[Docket No. 85-15; Notice 16]

Replaceable Light Source Information Federal Motor Vehicle Safety Standards; Lamps, Reflective Devices and Associated Equipment

ACTION: Notice of proposed rulemaking.

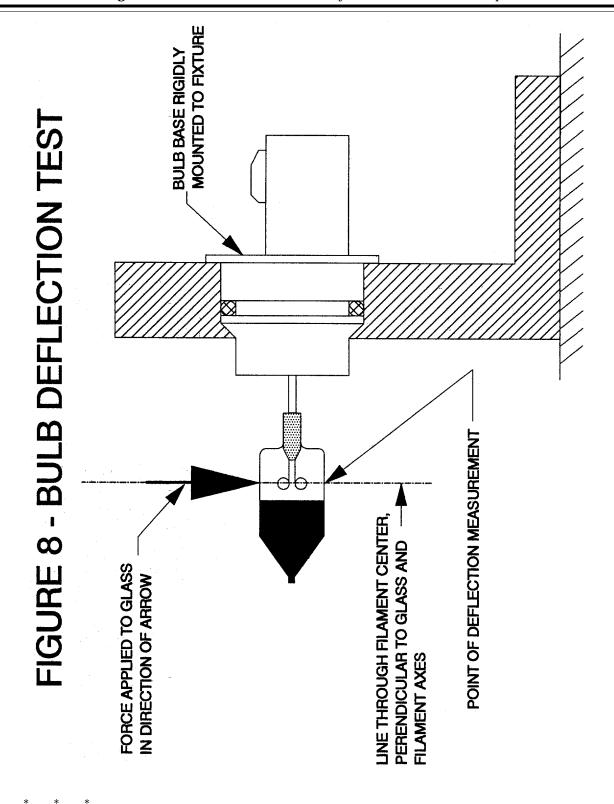
(c) The capsule, lead wires and/or terminals, and seal on each Type HB1, Type HB3, Type HB4, and Type HB5 light source, and on any other replaceable light source which uses a seal, shall be installed in a pressure chamber as shown in Figure 25 so as to provide an airtight seal. The diameter of the aperture in Figure 25 on a replaceable light source (other than an HB Type) shall be that figure furnished for such light source in compliance with Section IV.B of Appendix A of part 564 of this chapter. An airtight seal exists

when no air bubbles appear on the low pressure (connector) side after the light source has been immersed in water for one minute while inserted in a cylindrical aperture specified for the light source, and subjected to an air pressure of 70kPa (10 P.S.I.G.) on the glass capsule side.

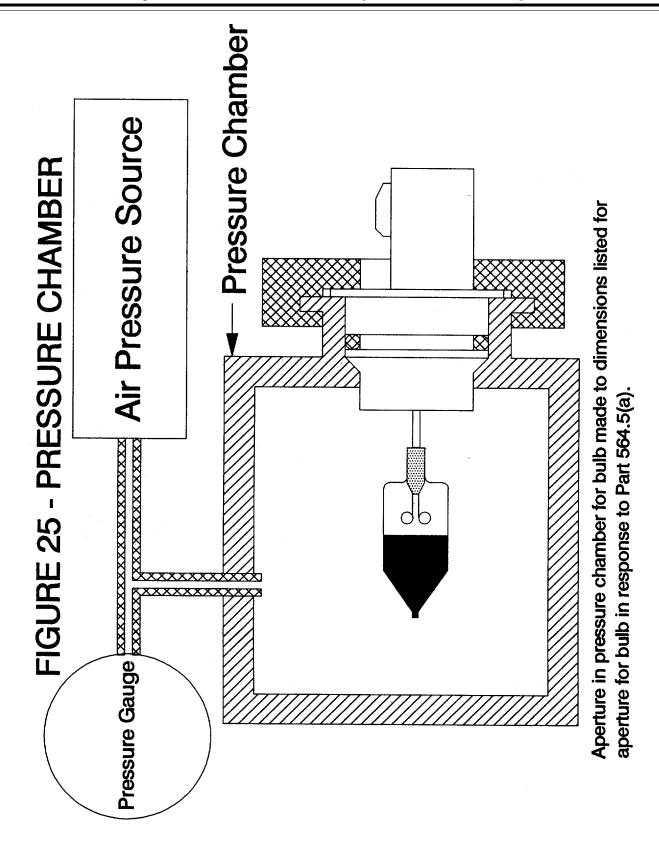
(d) After the force deflection test conducted in accordance with S9, the permanent deflection of the glass envelope shall not exceed 0.13 mm in the direction of the applied force.

S9 Deflection test for replaceable light sources. * * * Distance 'A' for a replaceable light source other than an HB Type shall be the dimension provided in accordance with Appendix A of part 564 of this chapter, section I.A.1 if the light source has a lower beam filament, or as specified in section I.B.1 if the light source has only an upper beam filament.
